**Development of Proposed New
Section 502.17 of the ISO rules,
*Voice System Communications
Requirements* (“Section 502.17”)**

July 9, 2019

Utility Orderwire Architecture

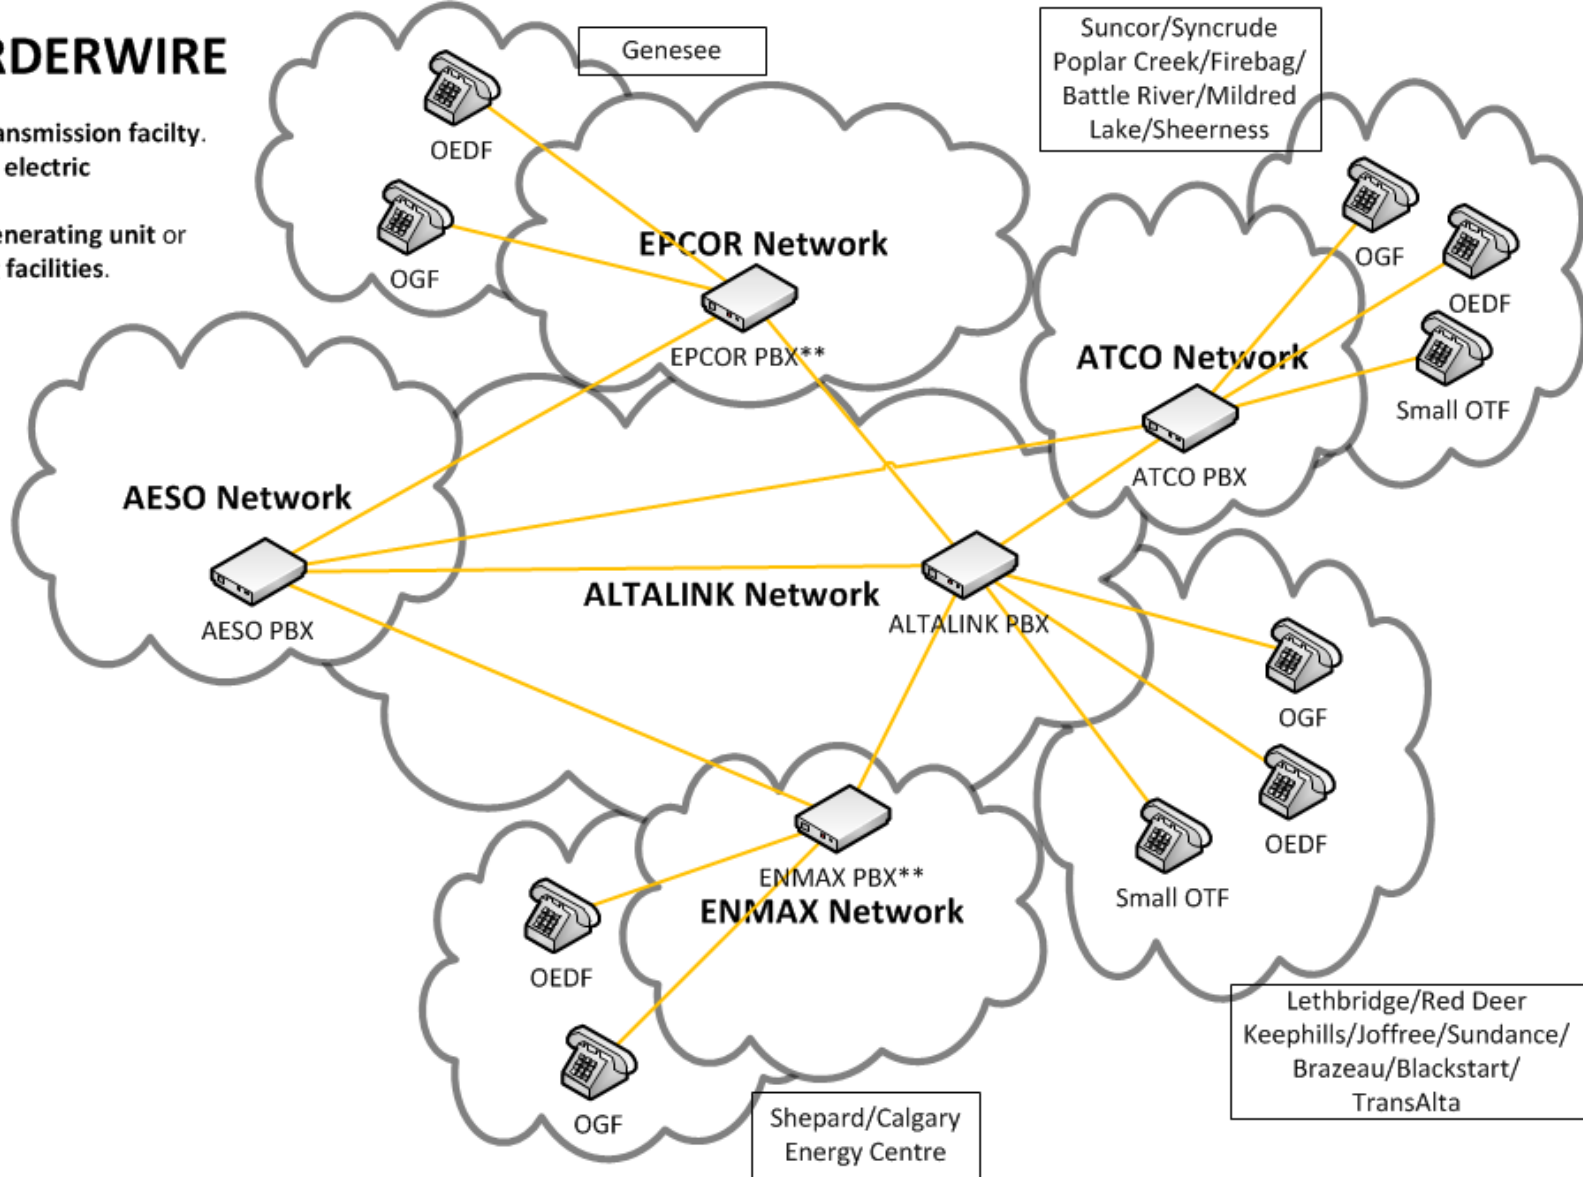
- AML and AE requested common understanding of the utility orderwire architecture:
 - Leverages the Utility Telecommunication Network
 - Core telecommunication infrastructure (microwave/fibre)
 - Carries critical power system services
 - Interconnect potential between most (or all) required parties
 - Several options evaluated by the AESO (next slides)
 - Same core telecommunication infrastructure regardless of option
 - Same physical interconnection points regardless of option
 - Primary difference is in the PBX and setup complexity
 - Considerations: reliability, complexity, troubleshooting, and cost

Extended Power Required For Intermediate Sites

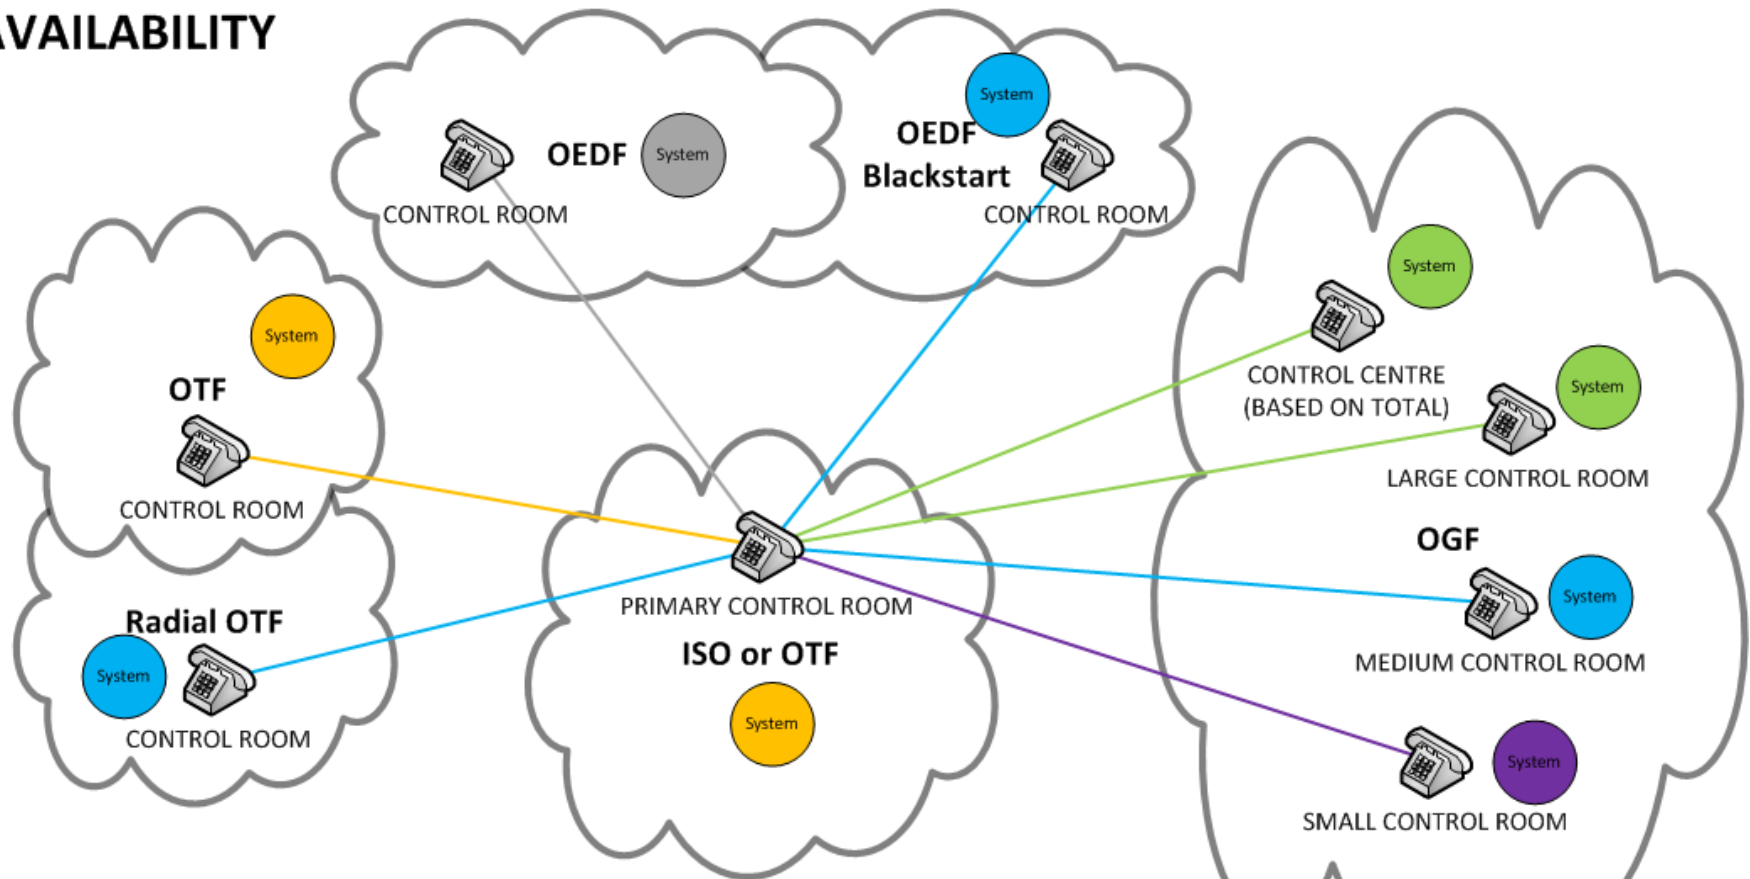
- AML and AE requested clarification on the extended power needs of intermediate sites:
 - AESO is proposing to update subsection 9(2) to clarify that the requirement applies to equipment located within the control centre.
 - Expectation that intermediate sites have a minimum of 8 hours battery backup
 - Understood good electric utility practice in Alberta
 - Consistent with proposed requirement for the proposed new Section 502.11 of the ISO rules, *Substation Technical and Operating Requirements*
 - Monitoring of intermediate sites to enable restoration as needed
